## United States Patent and Trademark Office

APPLICATION NO. FILING DATE		FIRST NAMED INVENTOR	ATTORNEY DOCKET NO.	CONFIRMATION NO.		
10/516,346	,346 11/30/2004 Yoshie		36856.1302	9508		
54066 75	590 03/10/2006	EXAMINER				
MURATA MANUFACTURING COMPANY, LTD.			MAI, A	MAI, ANH T		
C/O KEATING & BENNETT, LLP 8180 GREENSBORO DRIVE		ART UNIT	PAPER NUMBER			
SUITE 850			2832			
MCLEAN, VA	A 22102		DATE MAILED: 03/10/2000	DATE MAILED: 03/10/2006

## **DETAILED ACTION**

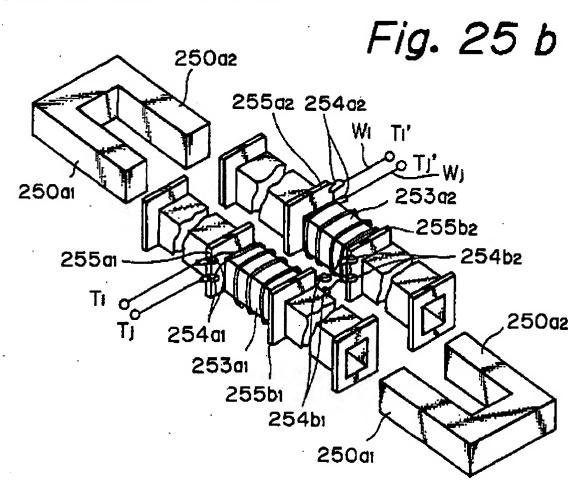
- a choke coil having first, second, third, fourth windings T1, T2, Ti, Tj and a magnetic core 250 constitutes a closed magnetic path in which the windings are wound [figure 25a];
- the first and second windings are wound in the same direction so that magnetic generates in the core are mutually strengthen when an in-phase noise current flows;
- the third and fourth windings are wound in the same direction so that magnetic
   generates in the core are mutually strengthen when an in-phase noise current flows;

As in claims 6, 9, 14, 19 Takagi discloses the first bobbin  $253_{a1}$  and second bobbin  $253_{a2}$  including the flange portion at both ends of the cylindrical body portion thereof, and outer periphery of the flange portion  $255_{a1}$  of the first bobbin contact with outer periphery of outer flange portion  $255_{a2}$  of the second bobbin; see fig. 25b.

As in claims 15, 26 figure 25B of Takagi shows the core members defined a closed magnetic path in which leading ends of the leg portion abut against each other.
